ADDENDUM NO. 02

68th/ Simonds Restriping and NE 170th Sidewalk Improvement Project

Bid No. 24-C3028

Friday April 19, 2024

SG1

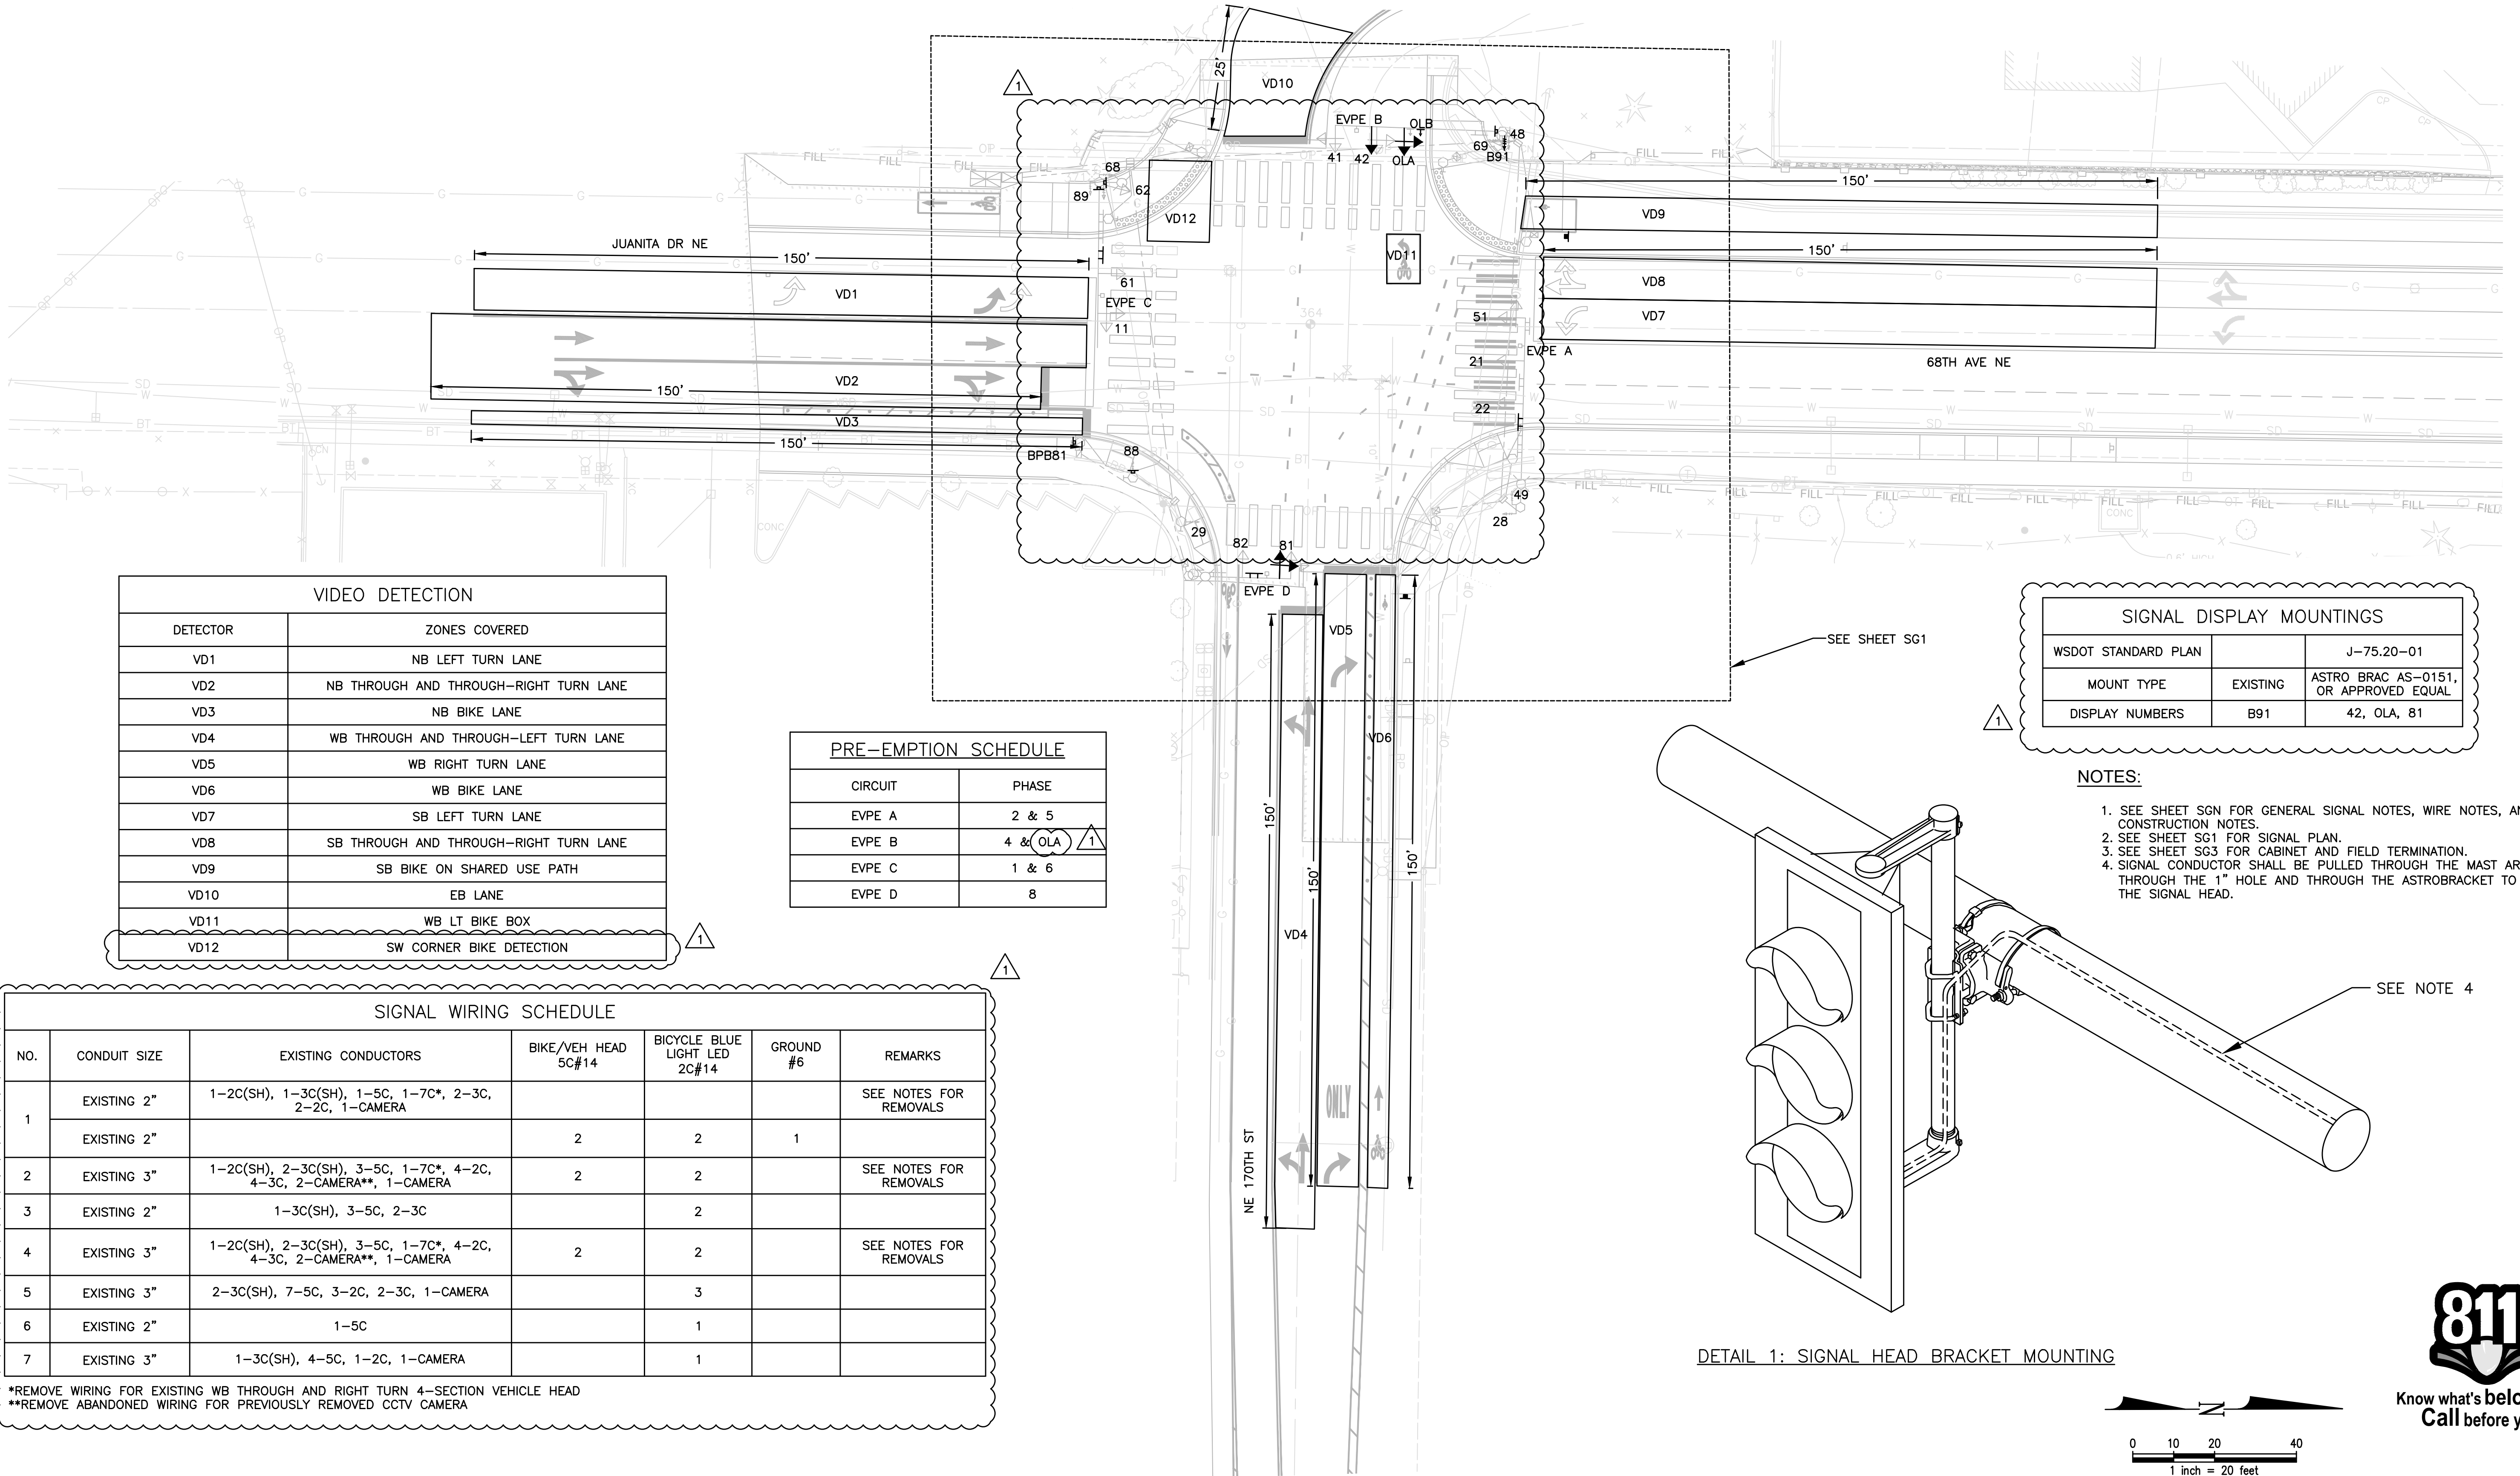
1. Call For Bids: Bid due date changed to April 24, 2024 at 2:00pm. (2 pages)
2. Bid Submittal Checklist: Bid Signature page added (1 page)
3. Bid Proposal Sheets (7 Pages)
 - a. Quantity change on Item A6. Uniformed Police Officer.
 - b. NE 170th Sidewalk bid items have been moved to Schedule B.
 - c. Schedule B Item number format changed to B1, B2, etc...
 - d. Quantity change on B29. (formerly A52) Plastic Wide Line.
 - e. Quantity change on B30. (formerly A53) Plastic Stop Line.
 - f. Quantity change on B37. (formerly A60) Green MMA Bike Lane
 - g. New item: B38. Plastic Crosswalk
 - h. Bid Signature Page: Working days changed to 60 Days.
4. Appendix D: Traffic Control Plan. (2 pages)
5. Plans sheets changes: CH04, CHD01, SGN, SG1, SG2, SG3. (6 pages)

1	4/19/24	170TH & JUANITA INTERSECTION			
No	Date	Revision	By	Appr

SG2

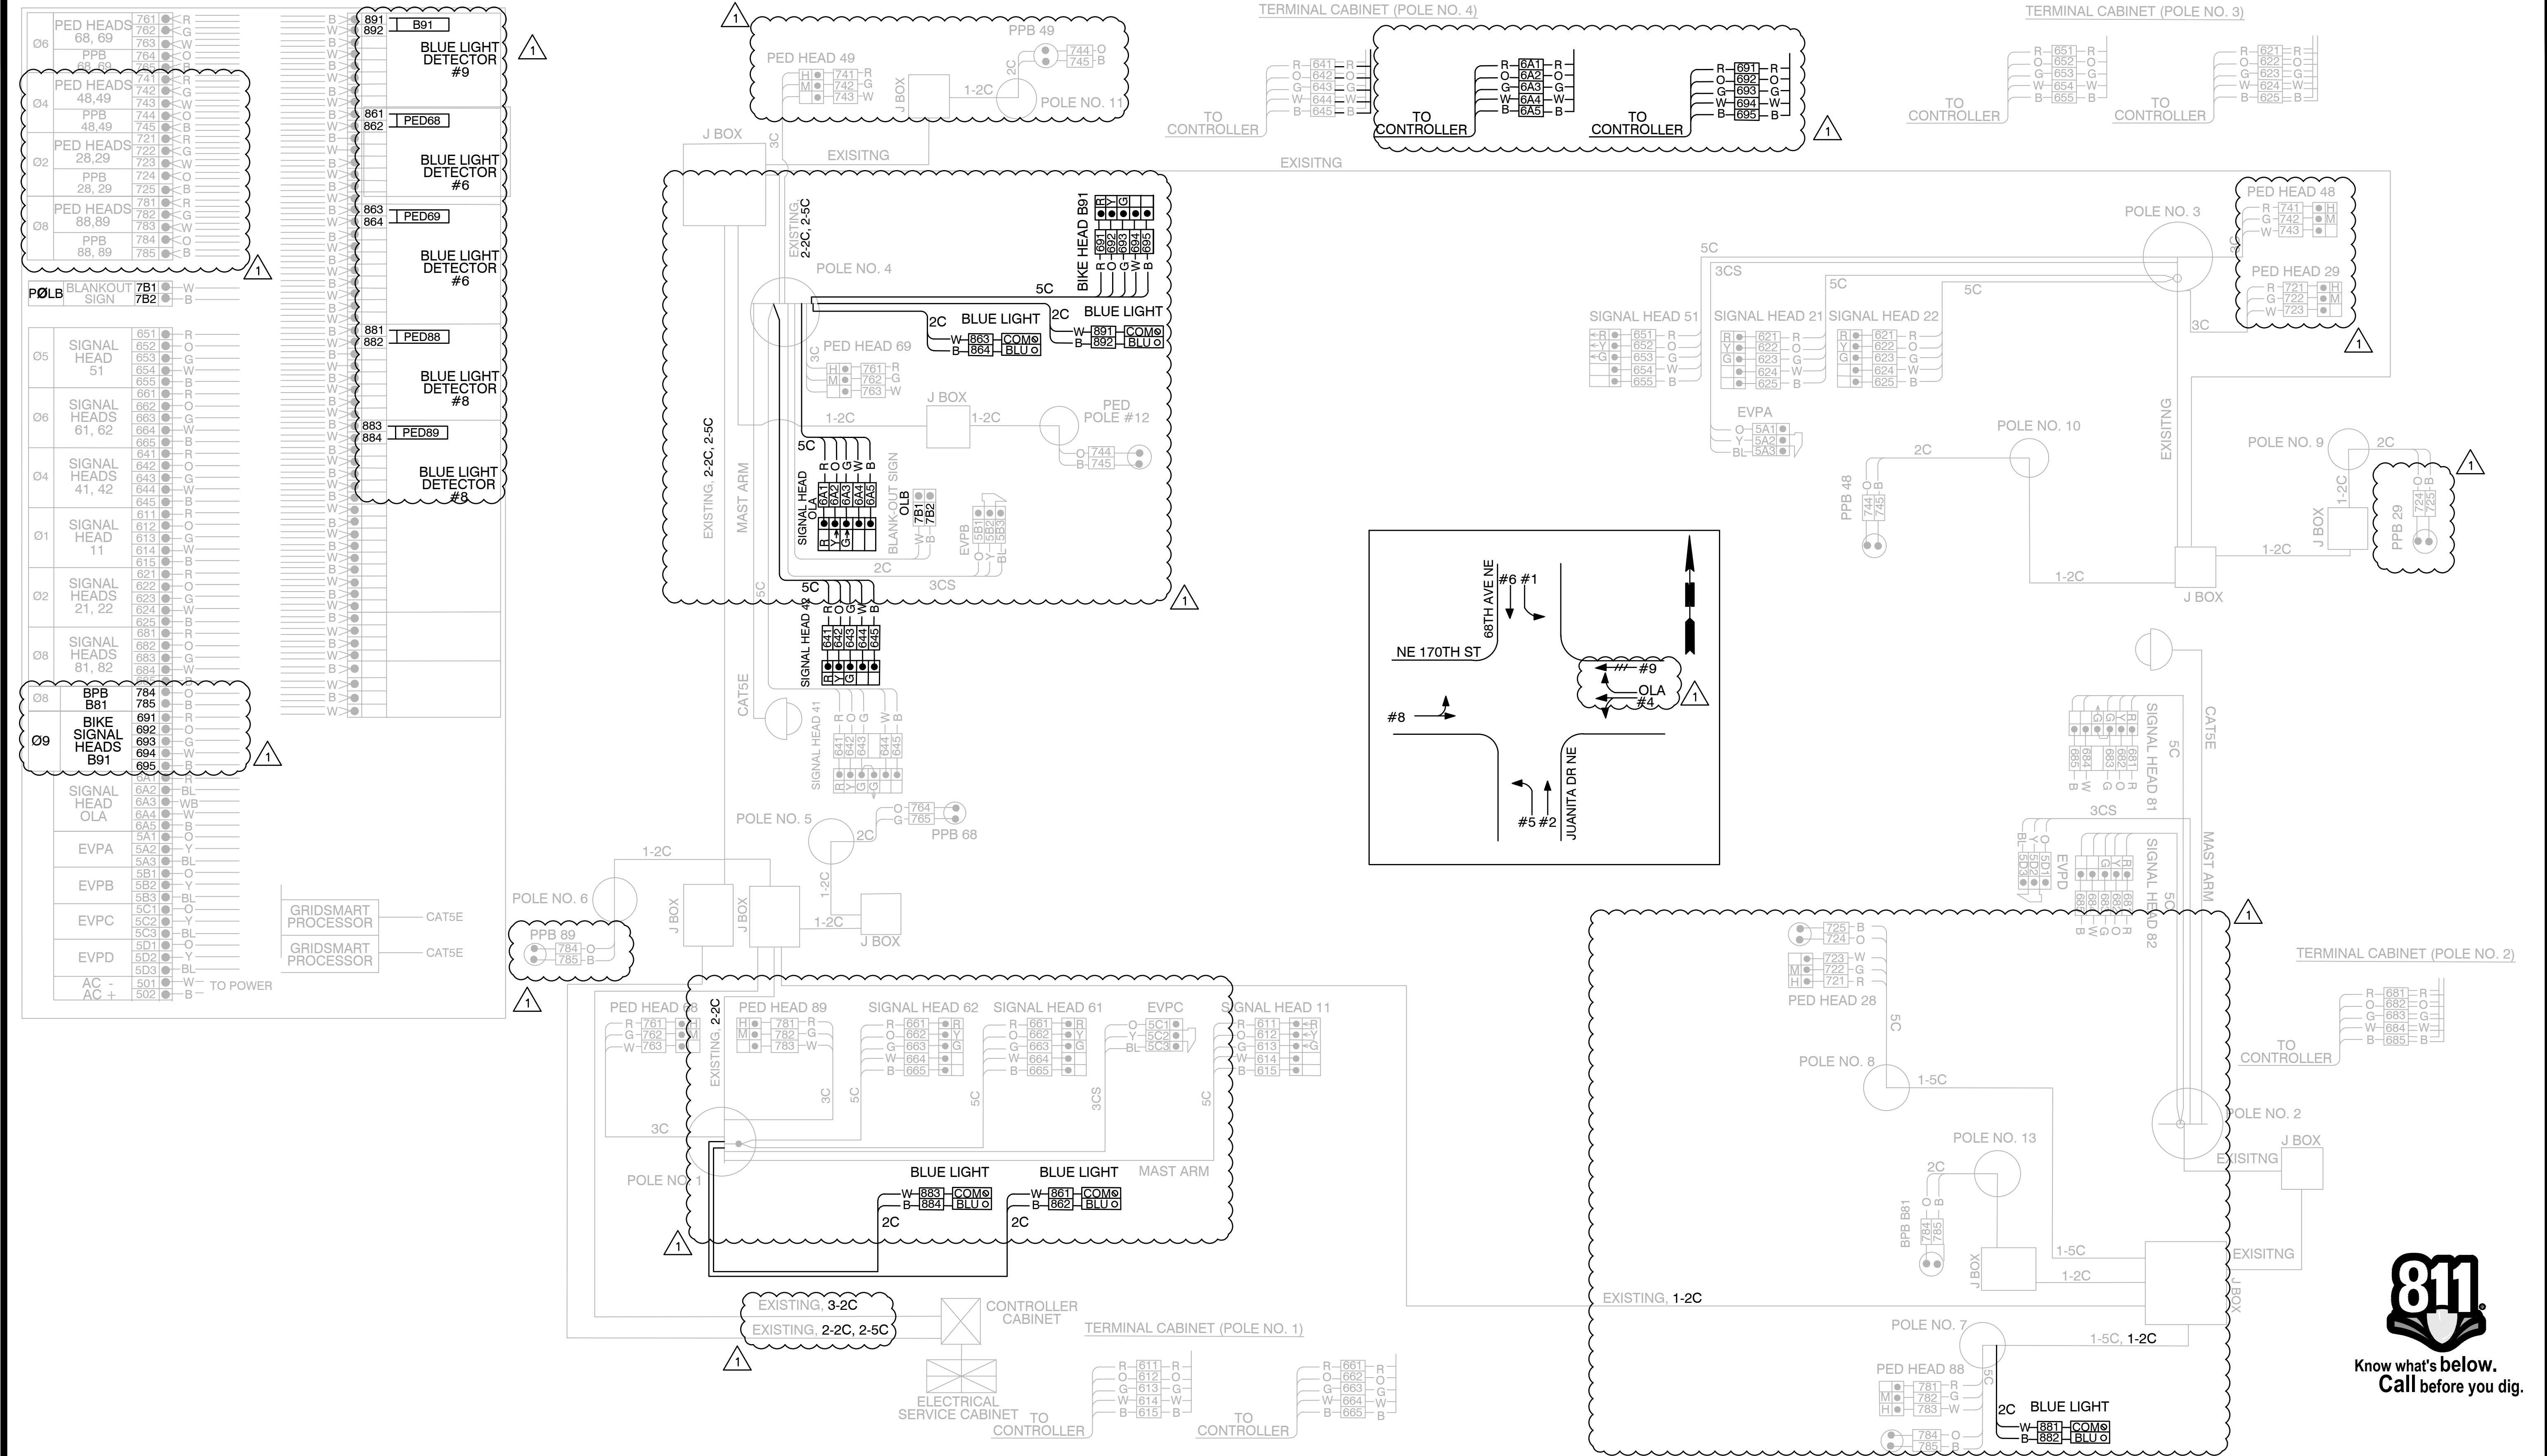
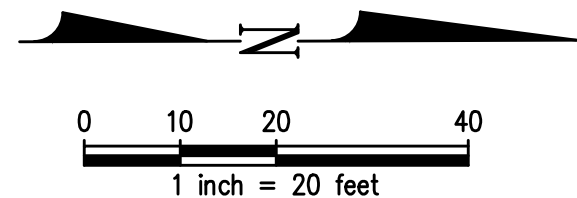
1	4/19/24	170TH & JUANITA INTERSECTION			
No	Date	Revision	By	Appr
